**Interpretation Number:** 2-03/01  
**Topic:** Carrier Extend (/R/)  
**Relevant Clauses:** 36.2.4.15  
**Classification:** Unambiguous

### **Interpretation Request**

### **Interpretation for IEEE std 802.3-2000**

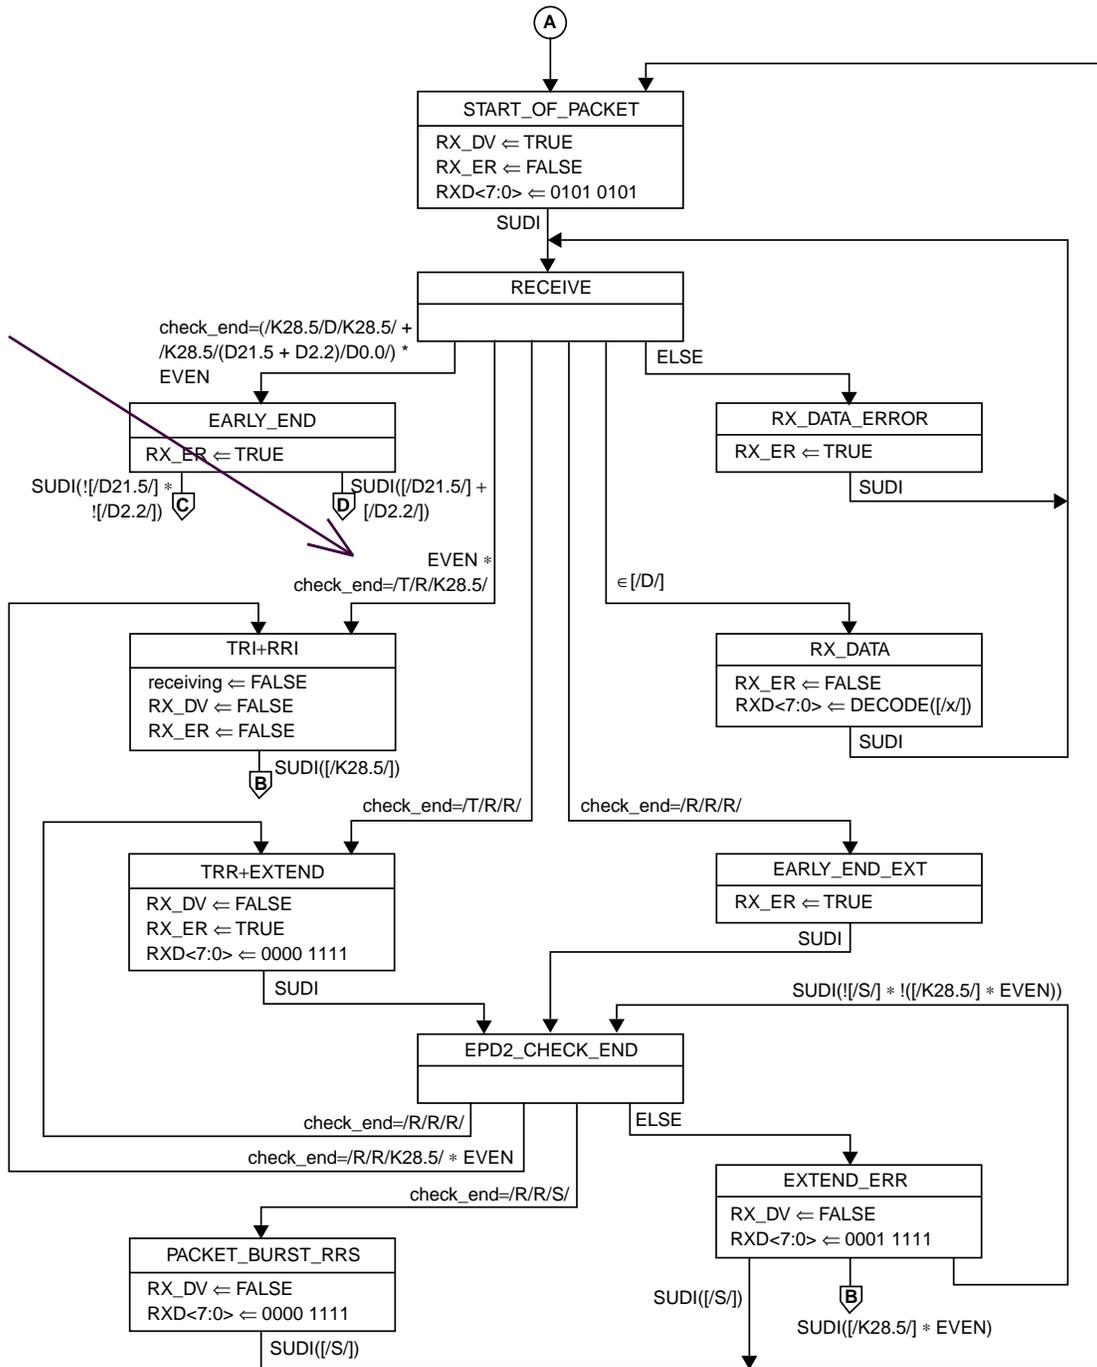
It appears that the text in IEEE 802.3-2000 Section 36.2.4.15 d) (Carrier\_Extend) contradicts Figure 36-7b (PCS receive state diagram, part b). Subclause 36.2.4.15 reads as follows:

The text above seems to imply that carrier extensions for the purpose of byte alignment are not sent to the PCS client (i.e., the RS); a PCS-generated /T/R/R/ sequence used to align a succeeding // on an even boundary will be converted to a /T/R/ sequence by the receiving PCS, prior to delivery to the PCS client. The obvious inference is that carrier extension due to byte alignment is transparent to the PCS client, which makes intuitive sense from a layering point of view.

However, Figure 36-7b clearly indicates (as marked by the superimposed arrow) that the PCS layer must assert carrier extension to the PCS client in the case of byte alignment. A transition out of the Receive state to the TRR+Extend state is made when any /T/R/R/ sequence is received by the PCS, whether this is due to normal carrier extension or due to carrier extension for the purpose of byte alignment. Within the latter state, the carrier extend indication is sent to the PCS client.

Please clarify the apparent differences between the text and the figure. Also, please provide the underlying intent of the standard with regard to reporting carrier extensions generated by the PCS to the remote MAC/RS layers.

The 4th sentence of subclause 36.2.4.15 ‘Carrier\_Extend (/R/)’ Item d), clearly states that ‘An EPD of /T/R/R/ results in one /R/ being delivered to the PCS client’.

The inference therefore ‘that carrier extensions for the purpose of byte alignment are not sent to the PCS client’ is incorrect.

Further, the standard clearly shows in Table 35-2 ‘Permissible encoding of RXD<7:0>,RX\_ER, and RX\_DV’ that Carrier\_Extend /R/ is encoded as

RX\_DV = 0, RX\_ER = 1 and RXD<7:0> = 0x0F on the GMII. The transition marked in Figure 36-7b of the interpretation request, which results from receiving a /T/R/R/, will result in the encoding RX\_DV = False, RX\_ER = True and RXD<7:0> = 00001111 on the GMII.

Since the text requires an EPD of /T/R/R/ to result in one /R/ being delivered to the PCS client and the Figure 36-7b shows a /R/ being delivered to the PCS Client, encoded as required by Table 35-2, there appears to be no differences between the text and the figure. Attention is also drawn to subclause 1.2.1 'State diagram conventions' which states 'The state diagrams contain the authoritative statement of the functions they depict; when apparent conflicts between descriptive text and state diagrams arise, the state diagrams are to take precedence.'

Carrier Extend has to be asserted in this case as the Receive PCS has no knowledge of the duplex mode the MAC is operating in, nor has it knowledge if the /T/R/R/ it has received is the start of Carrier Extension or simply present for code-group alignment.
